HARTING Product Change Notification

Business Unit: Electronics **PCN/RJI/14/07/ABCD**
Product range: HARTING RJ Industrial® Date: 2014-01-28
Author: Matthias Fritsche Page 1/2
Title: New cable gland for Han3A RJ45 Hybrid plugs

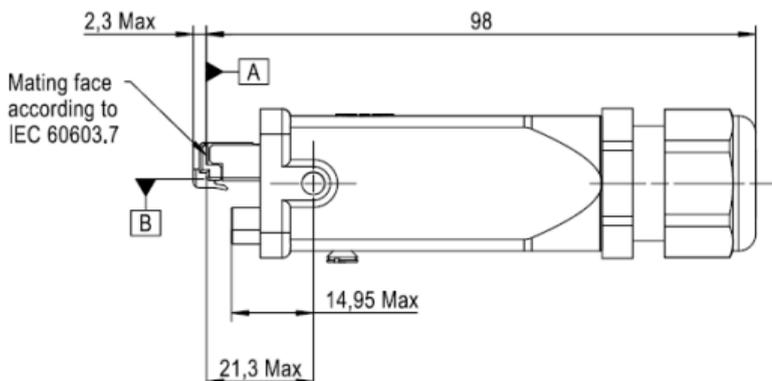
This change no electrical parameter of the product. Only the length of the product increased a little bit. The new cable gland offer a faster assembly and a better performance regarding the pull out force for the cable. Here the modification is visible:

Old design:

New design:
